U.S. Patent Application Serial No. 10/649,801 Reply to OA dated September 29, 2004

U.S. SER. NO. 10/649,801
Reply to Office Action dated September 29, 2004
Inventor: Kunihiko TAKEUCHI
Docket No.: 031089
ANNOTATED SHEET SHOWING CHANGES

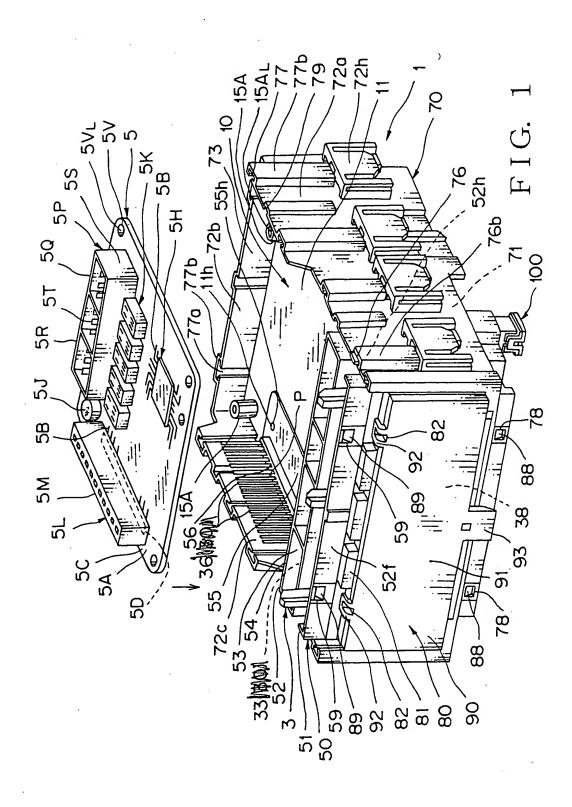
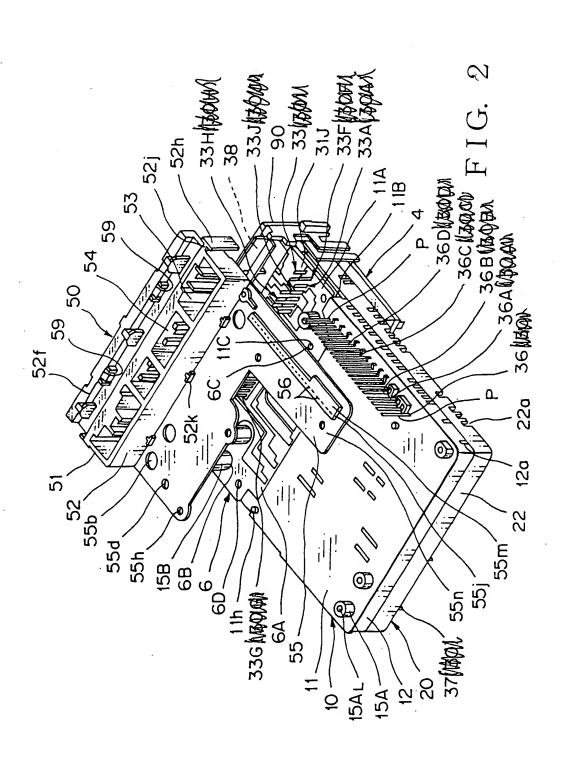
In the Office Action, objections to the drawings are made. Applicants have amended the drawings to remove the double numerals as requested. Applicants do not believe, however, that the use of numerals and alpha-numeric numerals are confusing when reference is made to the specification. Such a change is not believed to be necessary and would require complete revision of the specification and drawings without enhancing the understanding of the invention and reconsideration and removal of this objection is respectfully requested.

The attached sheets of drawings includes changes to Figs. 1, 2, 3, 4, 6, 7 and 11 to remove double numerals, as shown in the attached drawing sheets.
